Access Compliance Report

Public Rights-of-Way

(Curb Ramps)

Intersection ID: 11963	Main Street: S_GRAHAM_ST	Cross Street: W_4TH_ST	Location: S
ADA ID: 067FCCF69B3C	Ramp Type: Perp	Initial Pass/Fail: Fail	Overall Compliance: No
Severity Score: 21.25			
Codes/Mitigation Info/Possible Solution		Field Measurements/Component Compliance

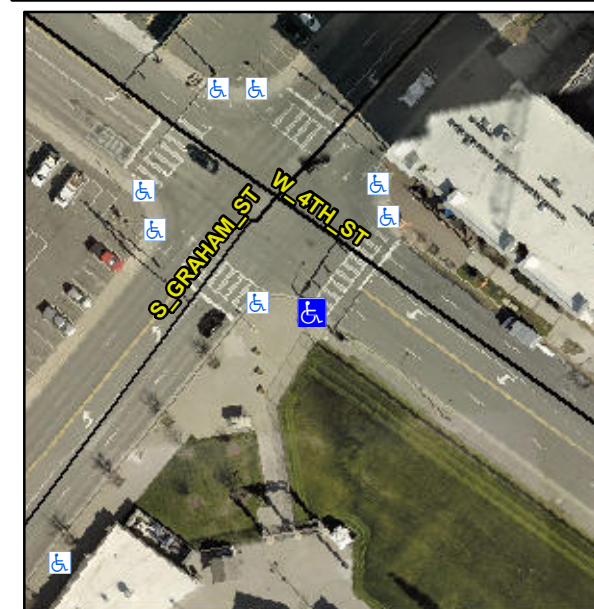
Not Found, R304.5.1, R304.2.2

Compliance	Description	Data	Compliance	Description	Data
N/A	Ramp Length (in)	80.0	No	Ramp Slope (%)	10.4
No	Ramp Width (in)	47.5	Yes	Ramp XSlope (%)	0.2
N/A	Flare Type LT	N/A	N/A	Flare Type RT	N/A
N/A	Flare Slope LT (%)	N/A	N/A	Flare Slope RT (%)	N/A
N/A	Flare Traversable LT?	N/A	N/A	Flare Traversable RT?	N/A
N/A	Landing Length (in)	N/A	N/A	DWS Provided?	N/A
N/A	Landing Width (in)	N/A	N/A	DWS Contrast?	N/A
N/A	Landing Slope (%)	N/A	N/A	DWS Length (in)	N/A
N/A	Landing X Slope (%)	N/A	N/A	DWS Full Width?	N/A
N/A	Landing Curb? (Y/N)	N/A	N/A	DWS Offset (in)	N/A
N/A	Shared Landing?	N/A			
N/A	Gutter Ponding?	N/A	N/A	Gutter Slope (%)	N/A
N/A	Gutter Lip Ht (in)	N/A	N/A	Gutter X Slope (%)	N/A
N/A	Painted X Walk1?	Yes	N/A	Painted X Walk2?	N/A
	X Walk 1 Direction	To NE		X Walk 2 Direction	N/A
N/A	X Walk 1 Width (in)	111.0	N/A	X Walk 2 Width (in)	N/A
	X Walk 1 Slope (%)	0.4		X Walk 2 Slope (%)	N/A
	X Walk 1 X Slope (%)	0.1		X Walk 2 X Slope (%)	N/A

Remove & Replace Entire Ramp.
